INCORPORATES PBY-5 BUREAU CHANGE #48

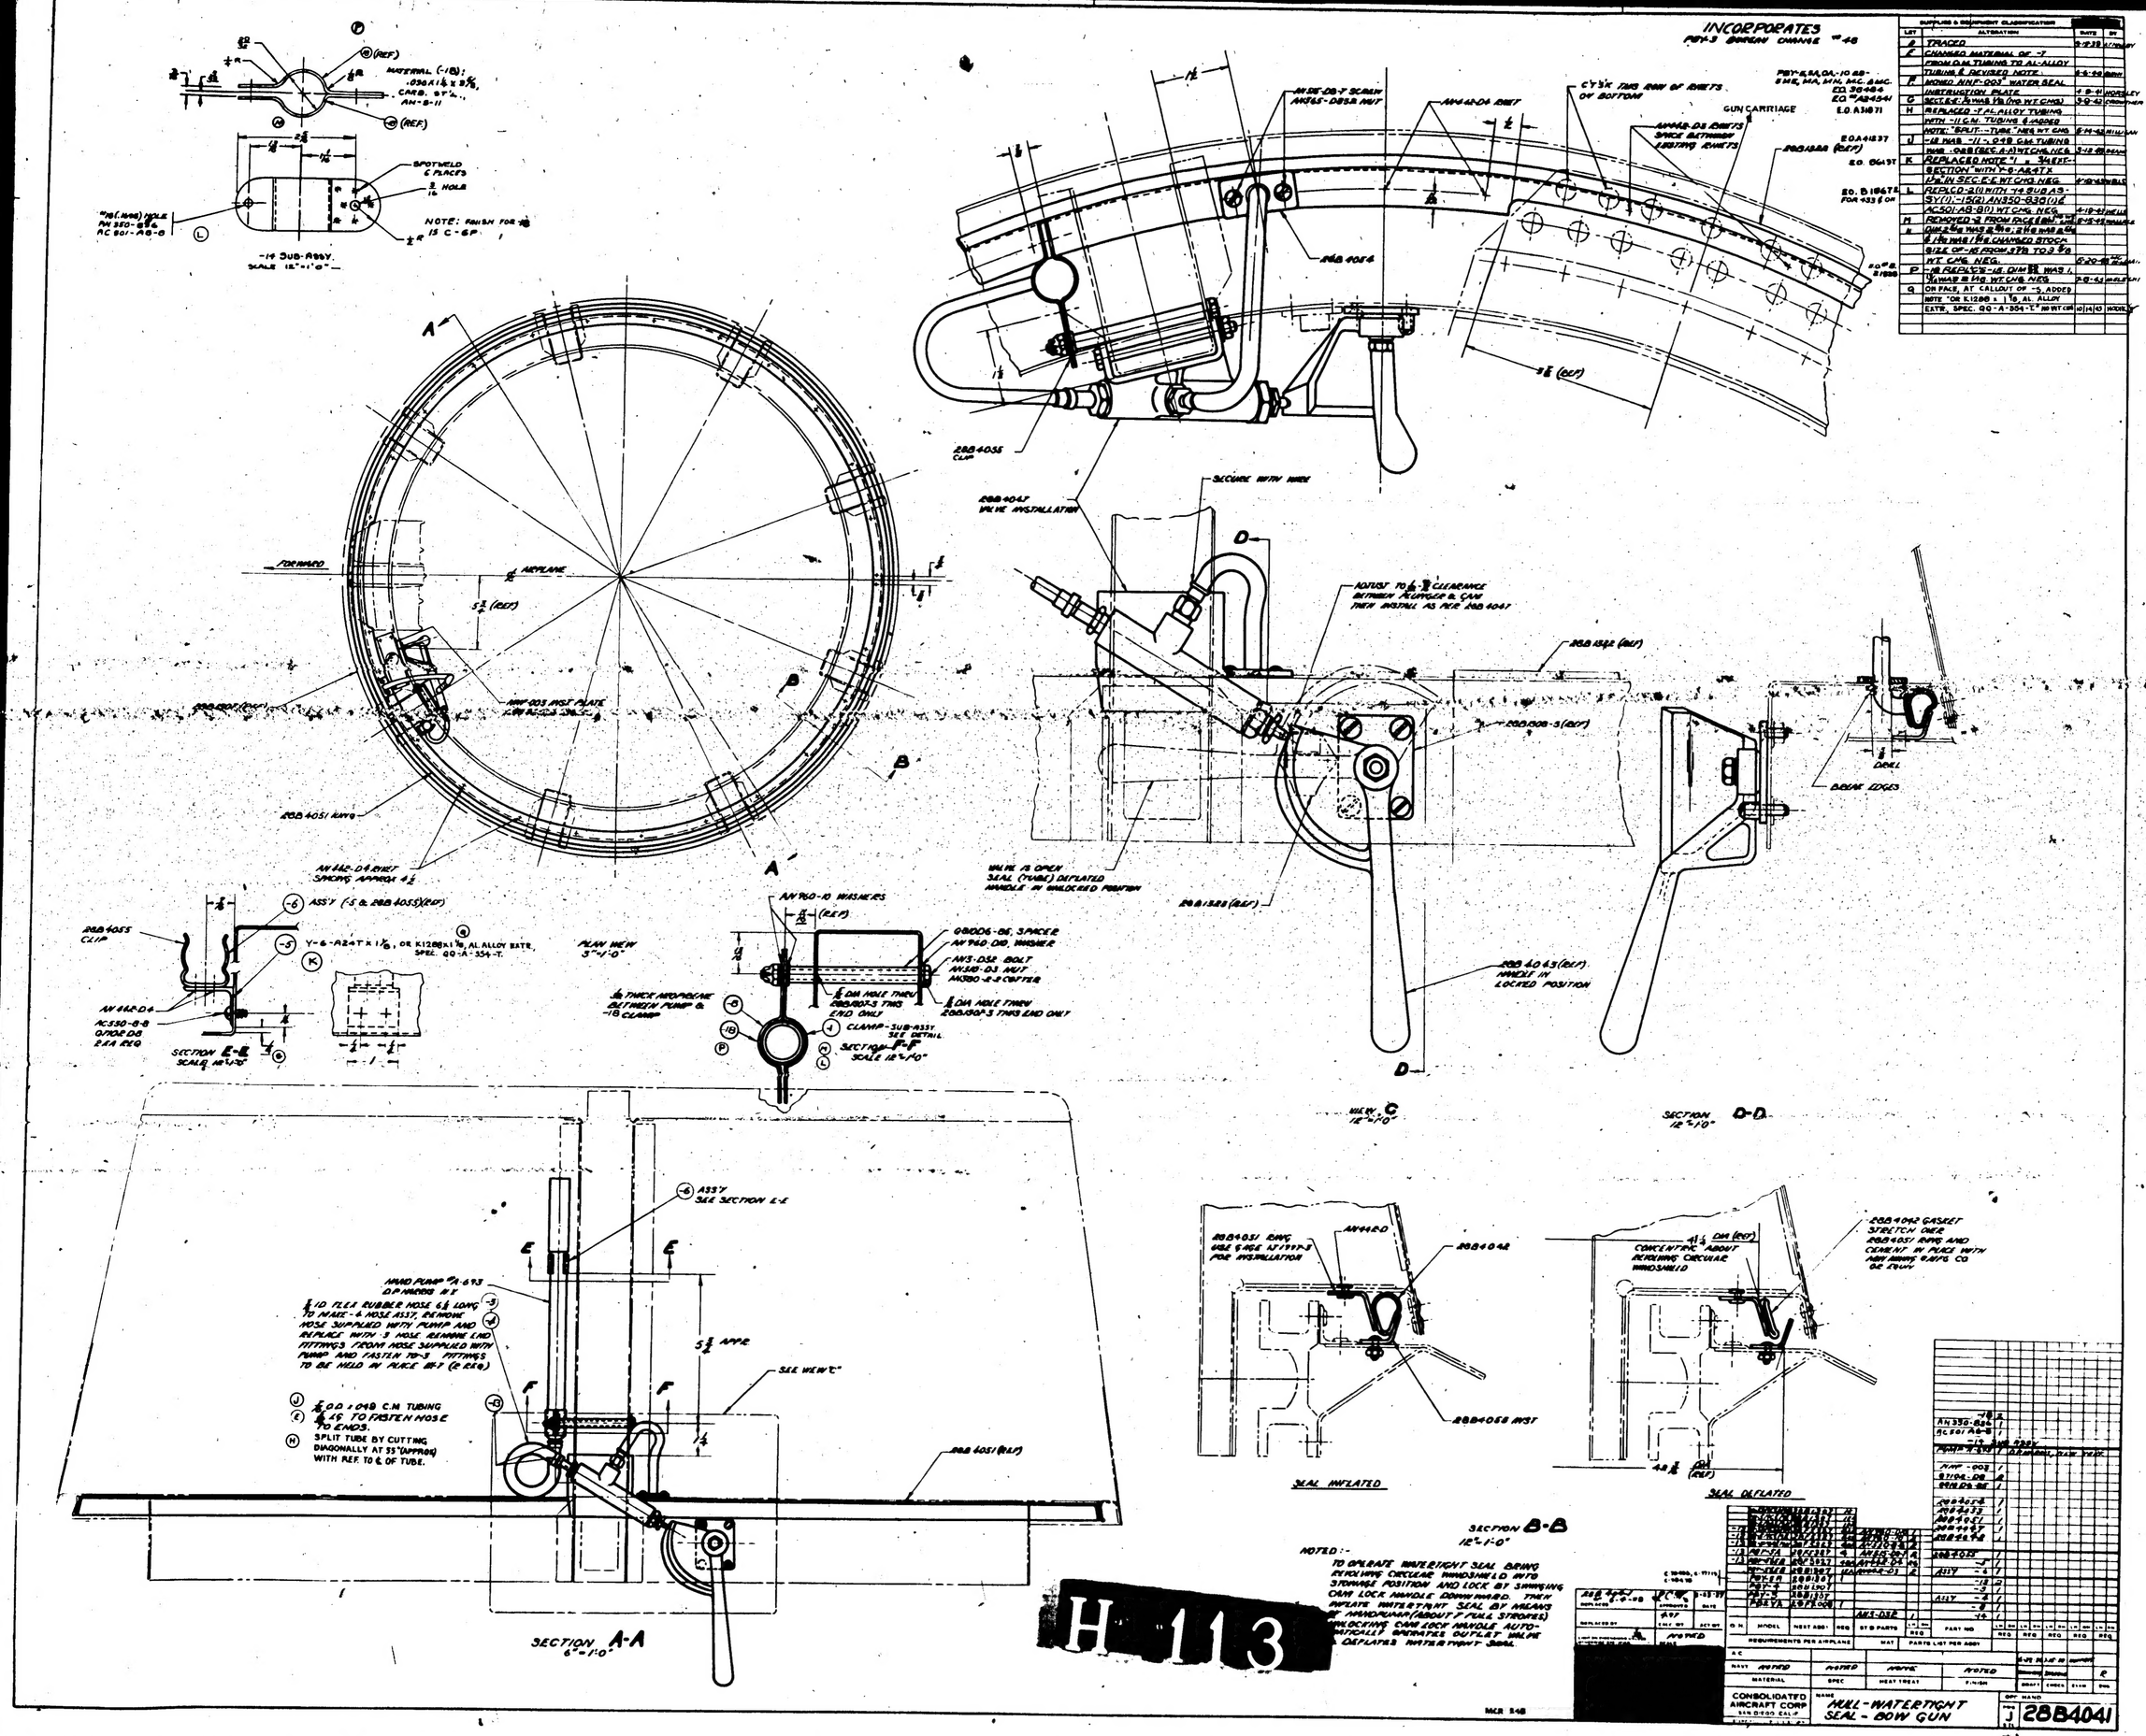
LET	ALTERATION	DATE	BY
A	TRACED	9-17-38	[illegible]
E	CHANGED MATERIAL OF -7 FROM CUM. TUBING TO AL-ALLOY TUBING & REVISED NOTE	8-5-39	[illegible]
F	MOVED NNF-003 WATER SEAL INSTRUCTION PLATE	4-8-41	HORSLEY
G	SECT. E-E: ADDED 1/16 (NO WT CHG)	9-9-42	[illegible]
H	REPLACED -7 AL. ALLOY TUBING WITH -11 C.M. TUBING & ADDED NOTE: "SPLIT--TUBE" NO WT CHG	6-14-43	[illegible]
J	-18 MAB. -11 x .049 C.M. TUBING MAB .048 (SEC. A-A) WT CHG. NEG.	3-18-44	[illegible]
K	REPLACED NOTE "1 x 3/4 EXT. SECTION" WITH Y-6-A24T X 1/16 IN. SEC. E-E WT CHG. NEG.	4-19-44	[illegible]
L	REPLACED -2(1) WITH "1/4 BUR AS SY(1)-1(2) AN350-930(1) & AC501-A8-8(1) WT CHG. NEG.	4-19-44	[illegible]
M	REMOVED -2 FROM PACK & ADD -3 (WAS 3/8 WAS 3/8 x 2 1/16 WAS 1 3/8 & 1 1/16 WAS 1 1/16 CHANGED STOCK SIZE OF -18 FROM 3 7/8 TO 3 3/8 WT CHG. NEG.	8-15-44	[illegible]
P	-18 REDUCE -18 DIA 1/32 WAS 1/16 WAS 1/8 NO WT CHG. NEG.	2-8-45	[illegible]

Q	ON FACE, AT CALLOUT OF -5, ADDED NOTE "OR K1288 x 1/16 AL. ALLOY EXTR. SPEC. QQ-A-334-T" NO WT CHG	10-14-45	[illegible]
